FINAL DRAINAGE REPORT

Foundation Lutheran Church

Towners Ave
Tract C, Paint Brush Hills Filing No. 13A
Falcon, Colorado

PCD File No. PPR2321
JOB NO. 191726

EXISTING SUB-BASIN ANALYSIS

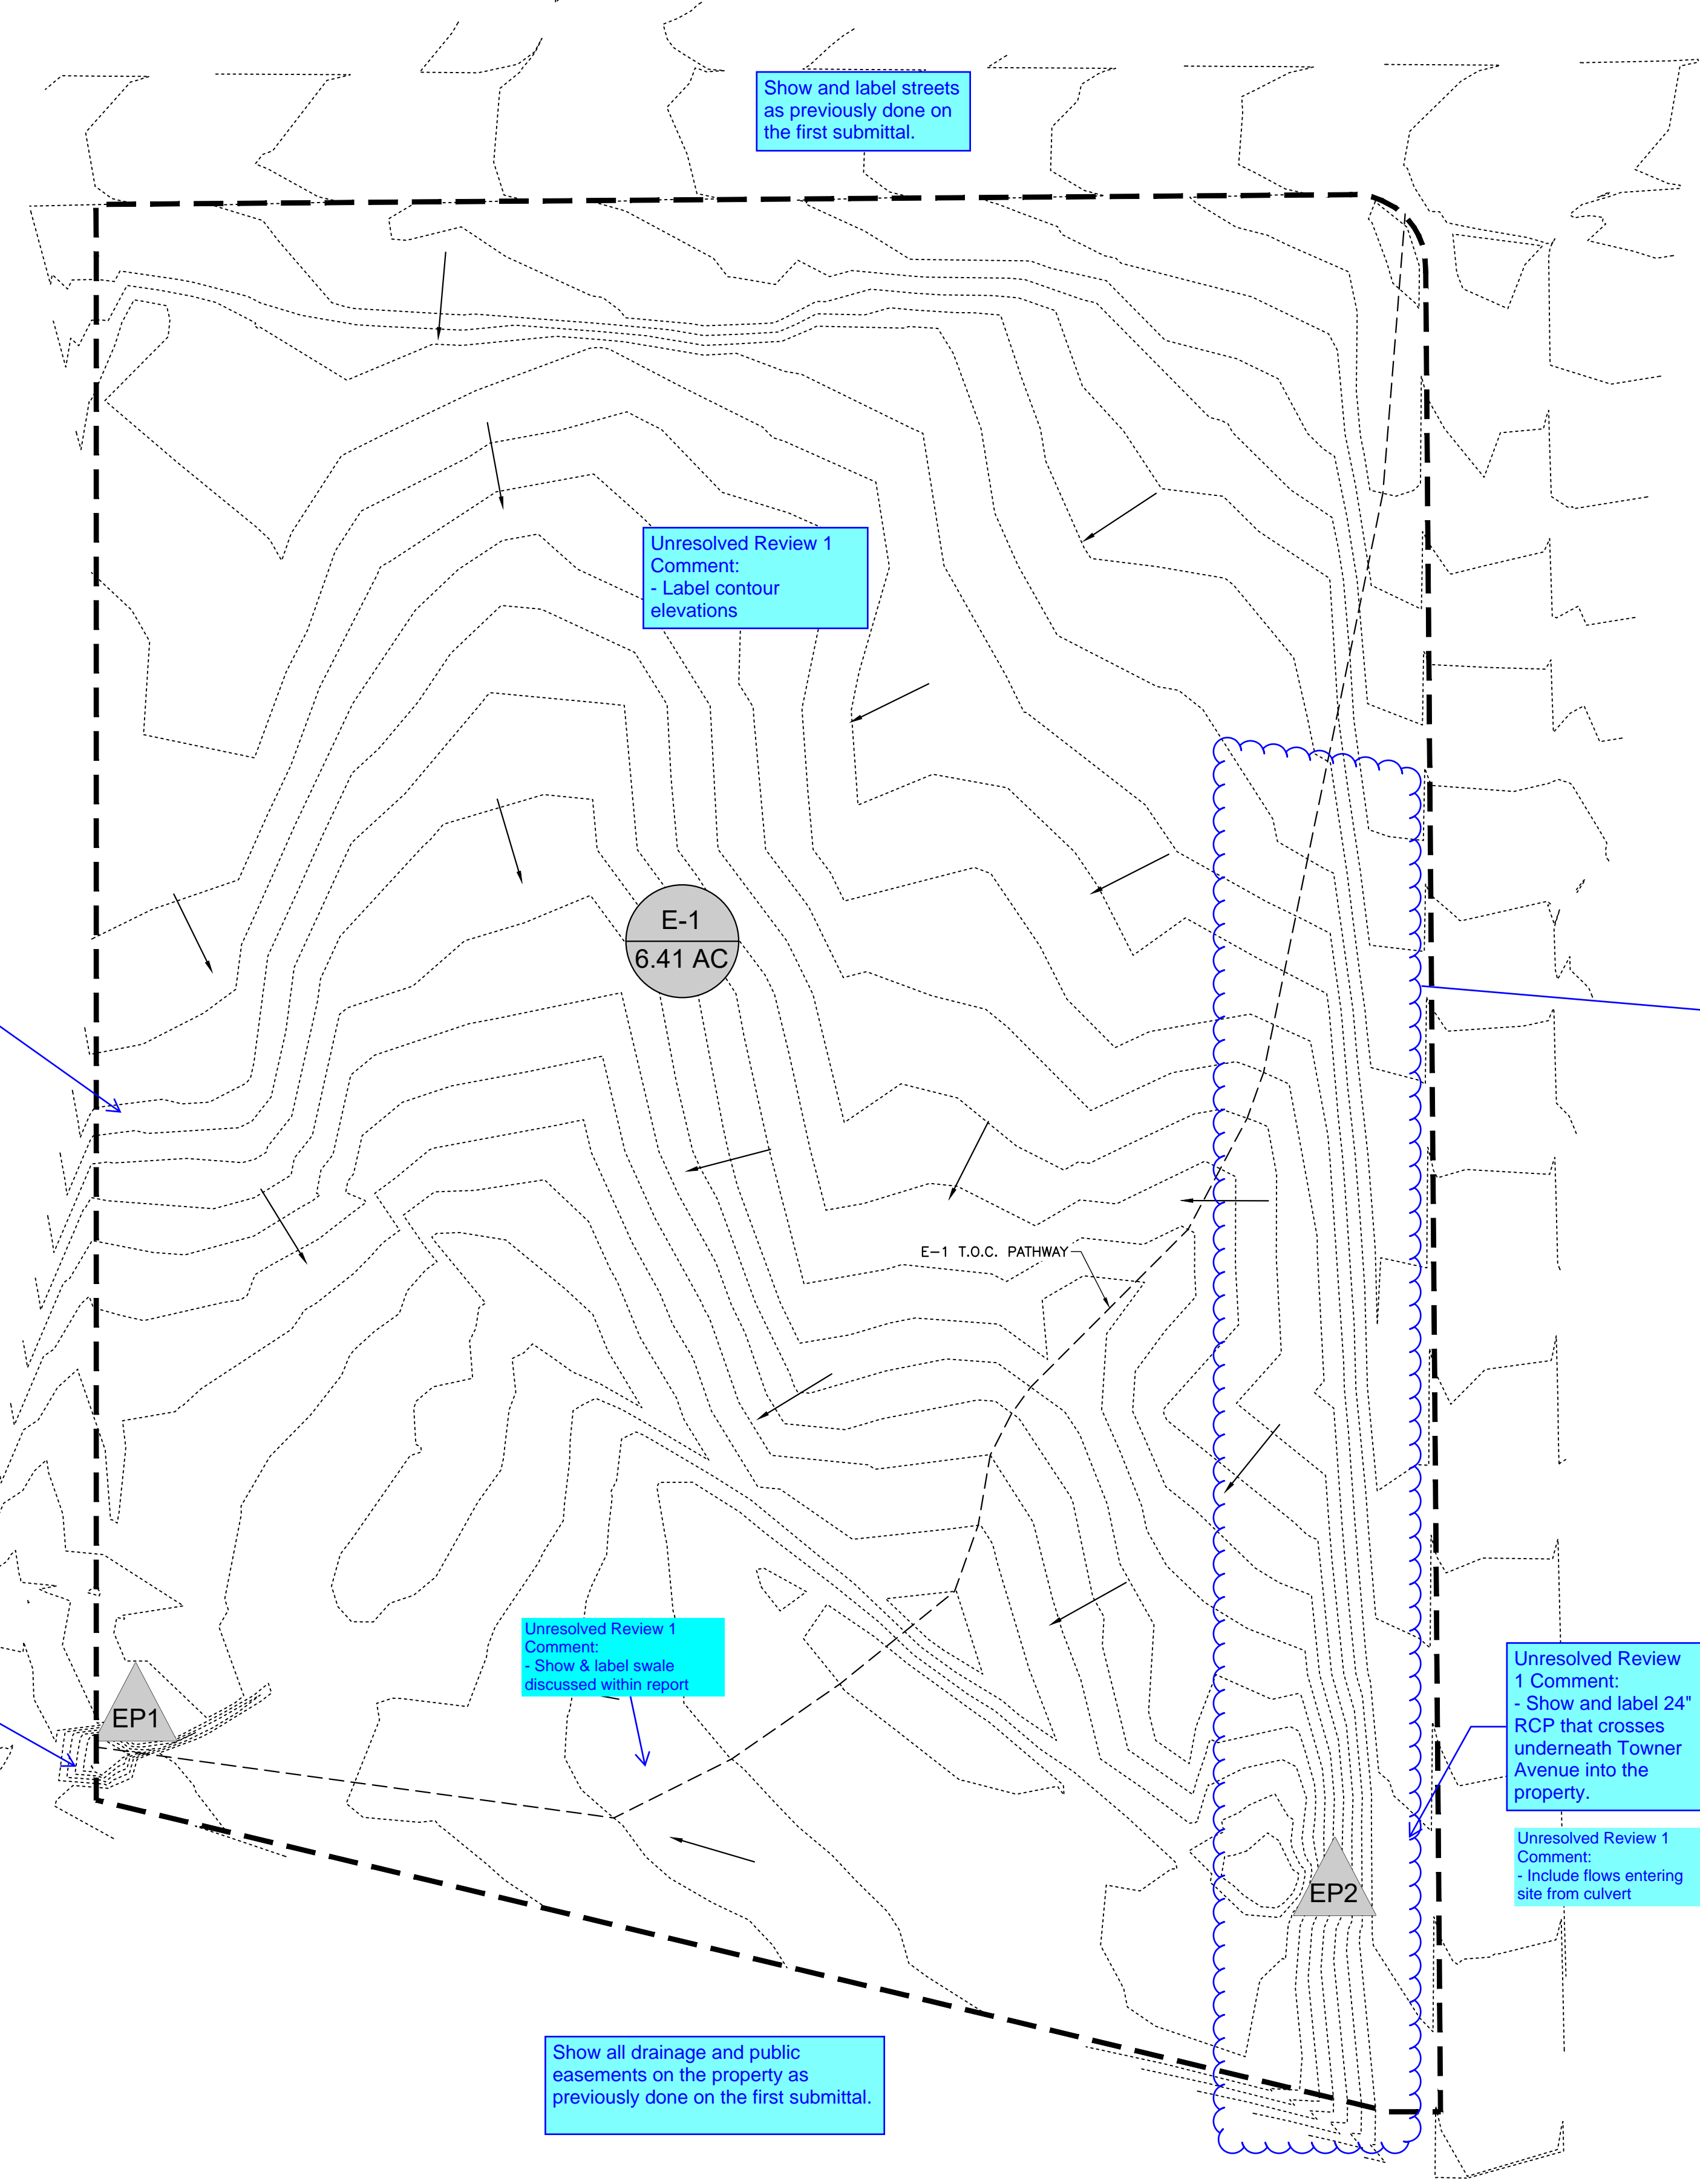
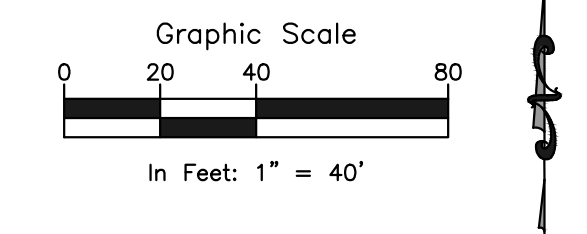
Missing EP2 in the table.

Unresolved Review 1 Comment:
- Label property line since it appears to be overlapped by basin boundary

Unresolved Review 1 Comment:
- Label contour elevations

Unresolved Review 1 Comments:
- Label contours.
- Are flows going towards Towner Avenue, if so then break this into a different sub-basin.

Unresolved Review 1 Comment:
- Show and label 36" RCP

Unresolved Review 1 Comment:
- Show & label swale discussed within report

Unresolved Review 1 Comment:
- Show and label 24" RCP that crosses underneath Towner Avenue into the property.

Unresolved Review 1 Comment:
- Include flows entering site from culvert

Show all drainage and public easements on the property as previously done on the first submittal.

Show and label streets as previously done on the first submittal.

SHEET NAME
PROPOSED SUB-BASIN ANALYSIS

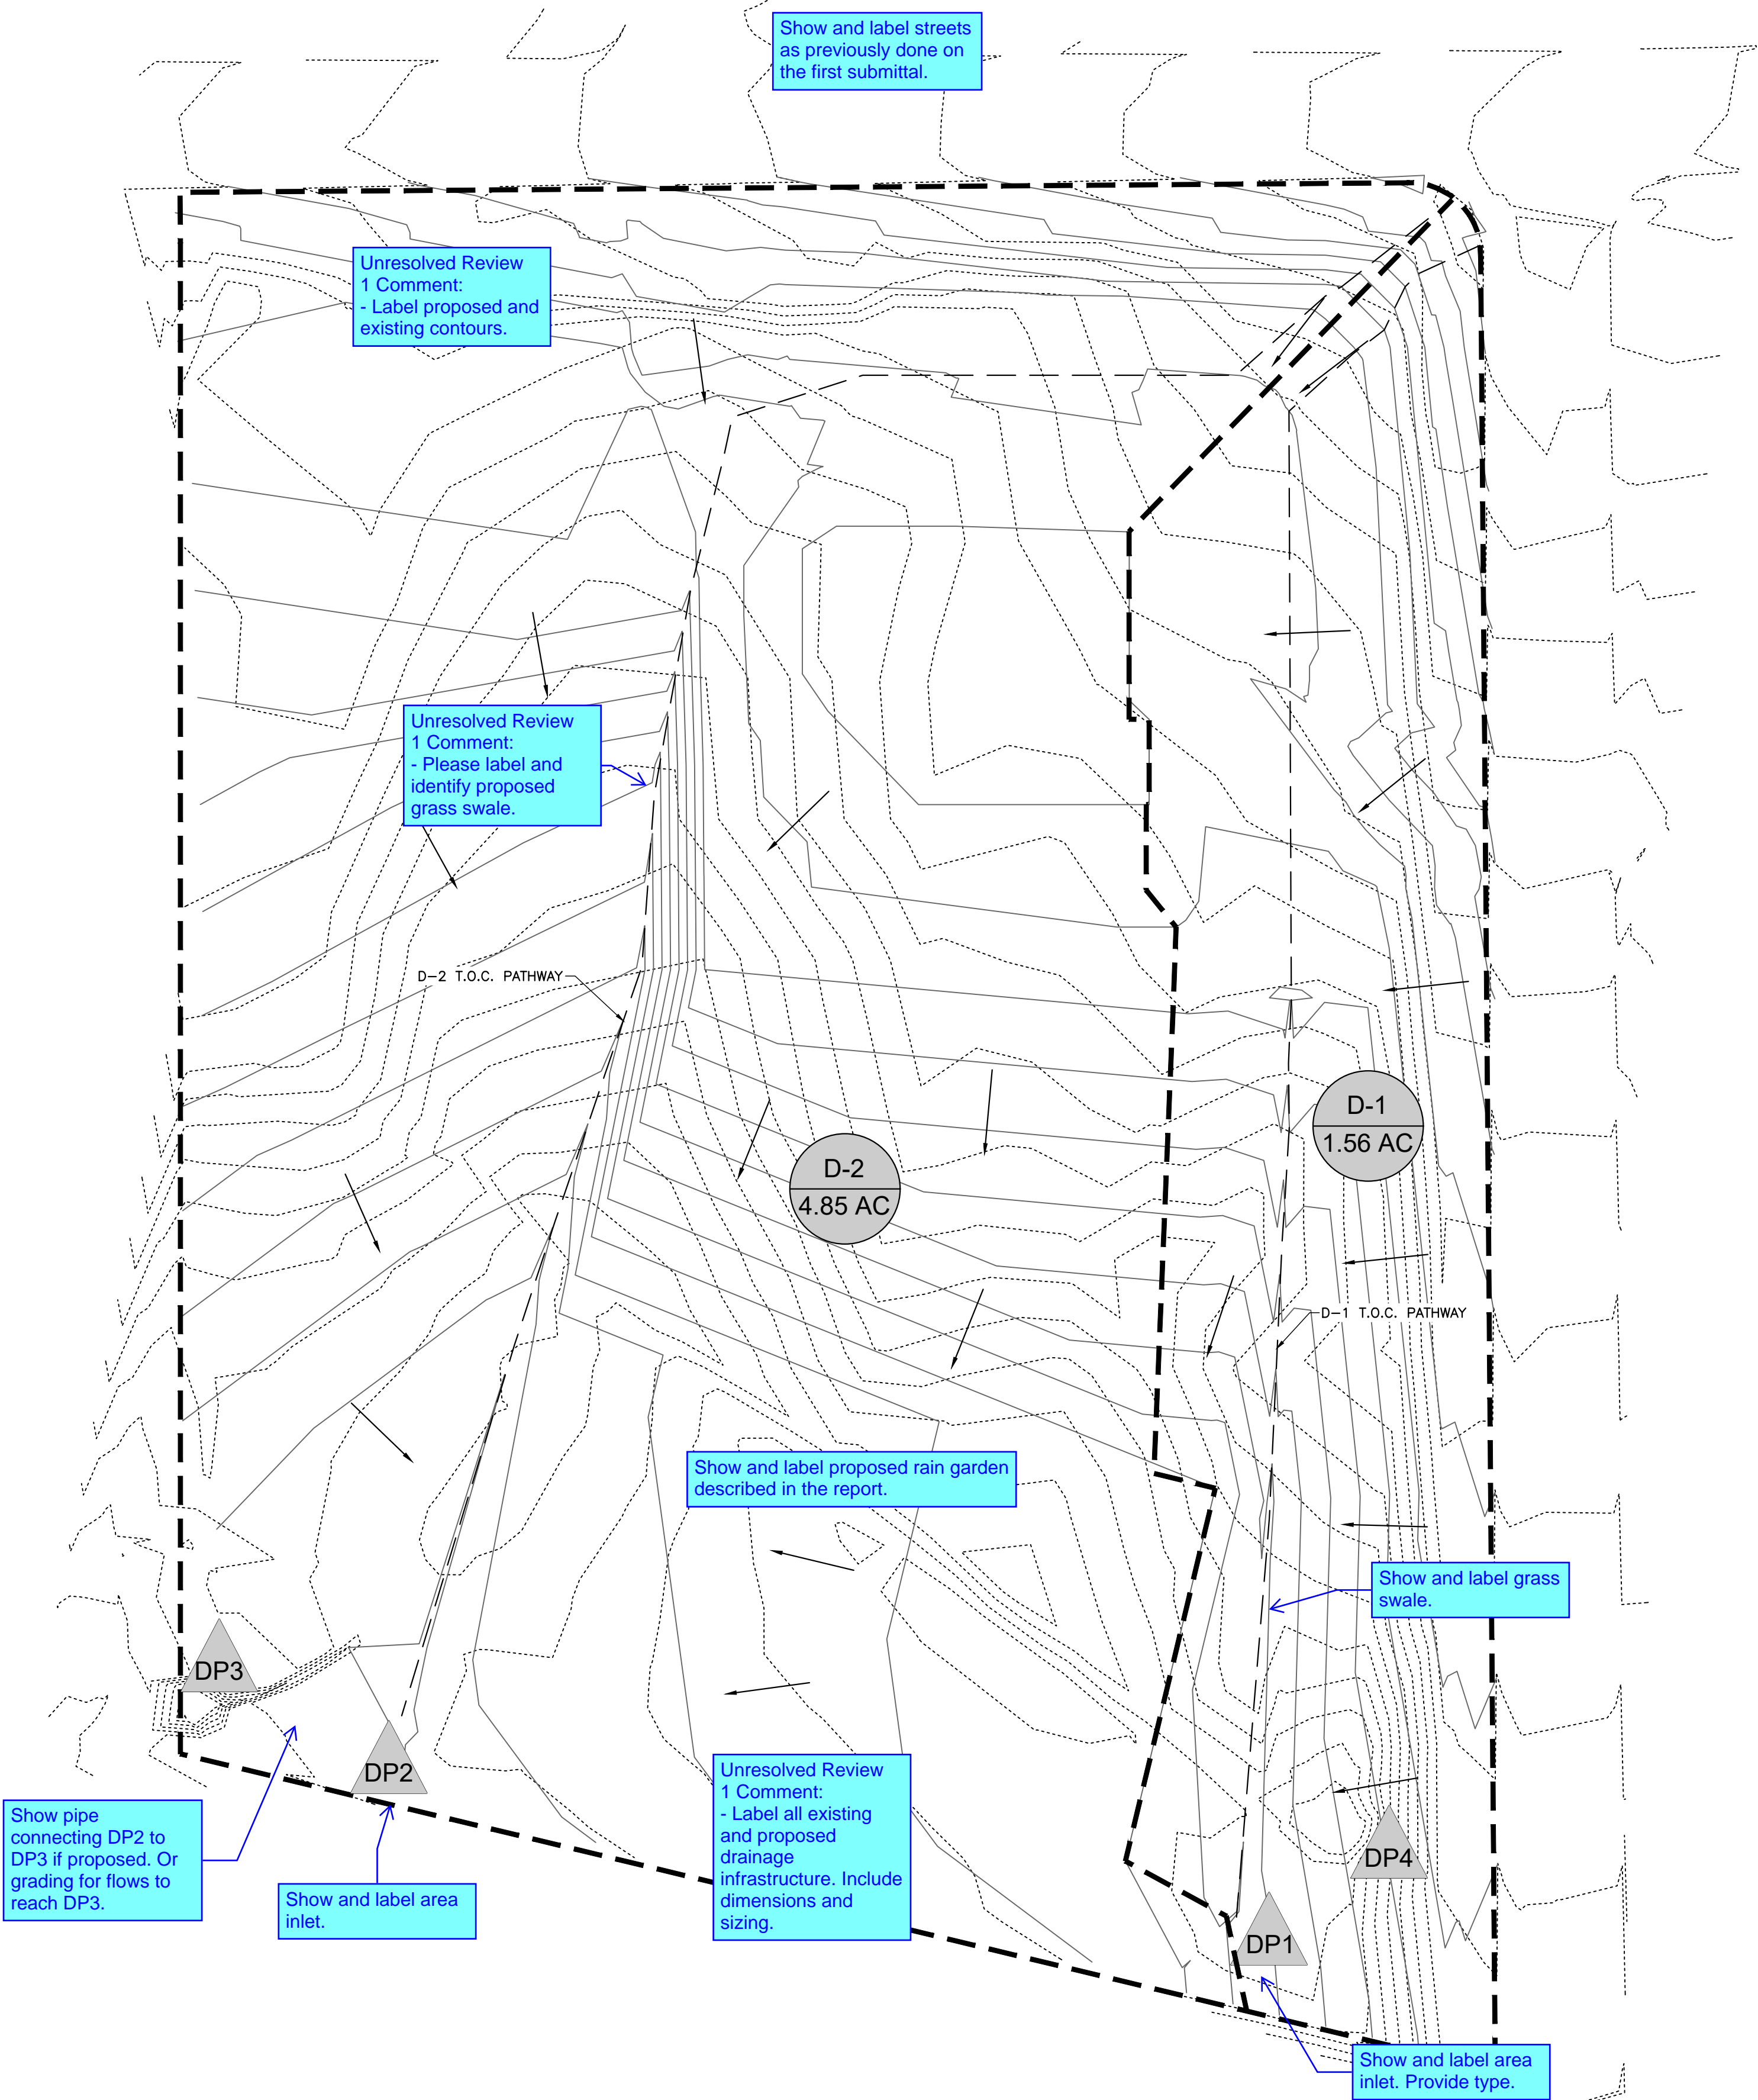
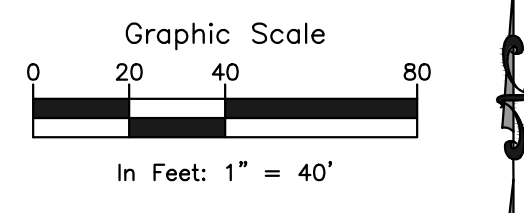
Unresolved Review 1 Comment:
- Add time of concentration path to legend

Show and label streets as previously done on the first submittal.

Unresolved Review 1 Comment:
- Label proposed and existing contours.

Unresolved Review 1 Comment:
- Please label and identify proposed grass swale.

Discuss DP3 and DP4 in the report and include in the summary table.

Show proposed structure and surfaces as previously done in first submittal.

Unresolved Review 1 Comment:
- Show and label all drainage and utility easements.

Provide a summation table for current historic conditions and developed flow conditions

Show and label proposed rain garden described in the report.

Show and label grass swale.

Show pipe connecting DP2 to DP3 if proposed. Or grading for flows to reach DP3.

Show and label area inlet.

Unresolved Review 1 Comment:
- Label all existing and proposed drainage infrastructure. Include dimensions and sizing.

Show and label area inlet. Provide type.
